REMARKS

CORRECTION OF THE DRAWINGS

FIG. 17

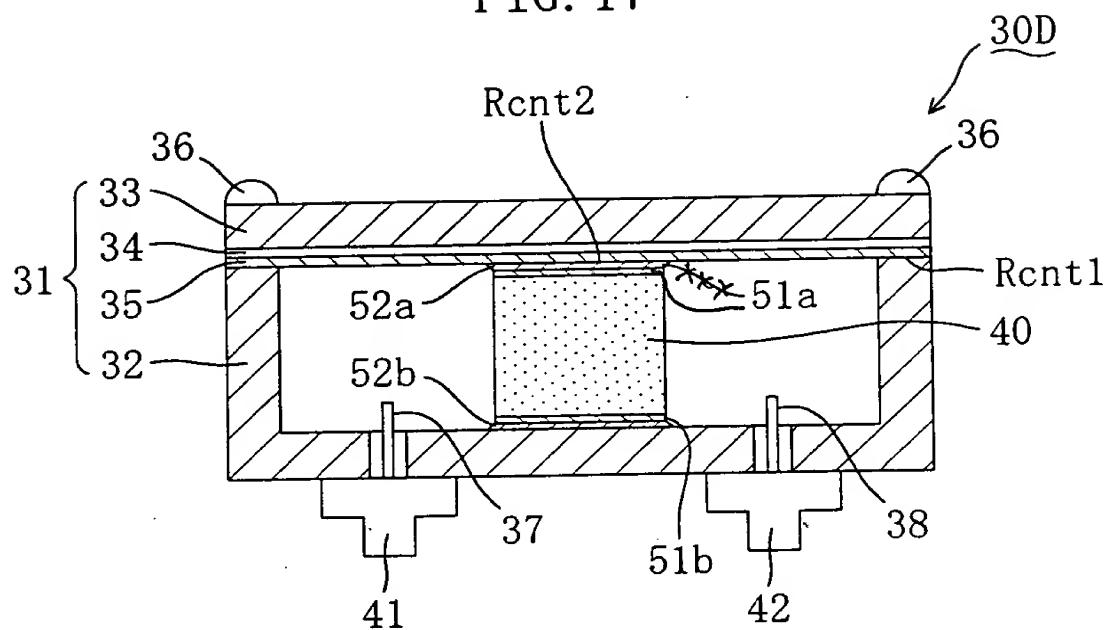
In the Office Action of July 24, 2002 (and reiterated in the Office Action of January 24, 2003) the Examiner objected to the drawings and has requested the Applicant to supply proposed corrections. Accordingly, submitted herewith are proposed corrections to Figures 17 and 20. With regard to Figure 17, the Examiner objected for the reason that reference number 52a does not appear to be included in the specification at page 47. Upon review, Applicants respectfully note that, in fact, reference numeral 52a does appear in the specification at line 13, although that reference numeral was not shown in bold print as were the other reference numerals on that page.

However, in reviewing Figure 17, it does, nevertheless, appear that Figure 17 needs to be corrected, because the lead lines for numbers 52a and 51a appear to be pointing to the same structure. As made clear in the specification, solder (52a) is used to mechanically and electrically couple the dielectric 40 with the metallized layer 51a. Thus, the lead line for reference numeral 51a has been corrected to indicate the metallized layer in conformity with the description contained in the specification.
